Item ID: D3016-13 Accept \*N900040100\* Setup Start \*NS1\*  
 Revision ID: Stop \*NS2\*  
 Item Name: Bracket  
 Start Date: 9/17/12 Start Qty: 6.00 \*6\* Cust Item ID:  
 Required Date: 10/12/12 Req'd Qty: 6.00 \*6\* Customer:  
 Reference:

DRAWING NO. D3016	TITLE SEAT FRAME ASSEMBLY	REV. A	DART AEROSPACE LTD ENGINEERING ORDER	D.E.O. NO. D3016-A-1	SHEET NO. SHEET 1 OF 1	SCALE NTS
DRAWN 1	CHECKED UP	MFG. APPR. RE	APPROVED MP	DE APPR. H		
DATE 10.01.29	DATE 10.01.29	DATE 10.01.29	DATE 10.01.29	DATE 10.01.29	DATE 10.01.29

TO REVISE D3016-11 SADDLE'S HOLE SIZES

**D3016-11 SADDLE**

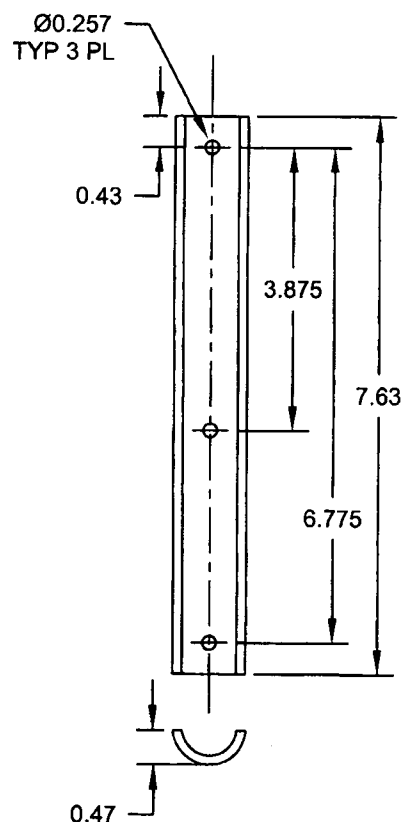
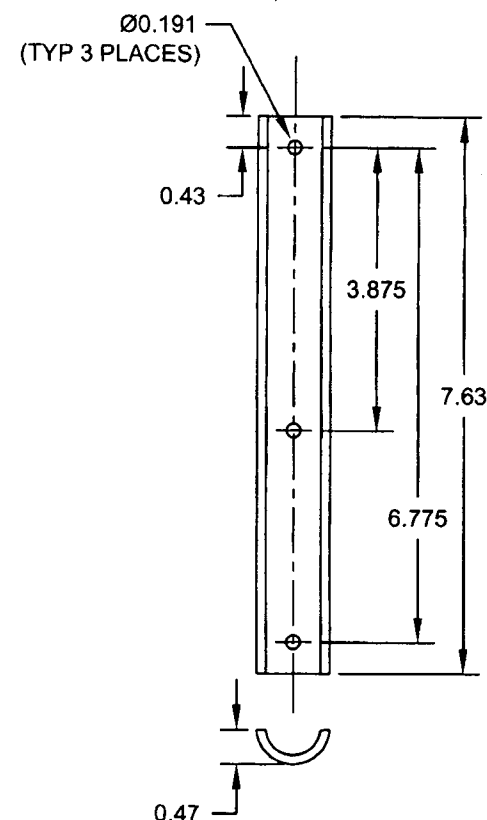
DETAIL D3016-11 SADDLE (SHEET 3): Ø0.257 TYP 3 PL WAS Ø0.191 (TYP 3 PLACES) AS SHOWN:
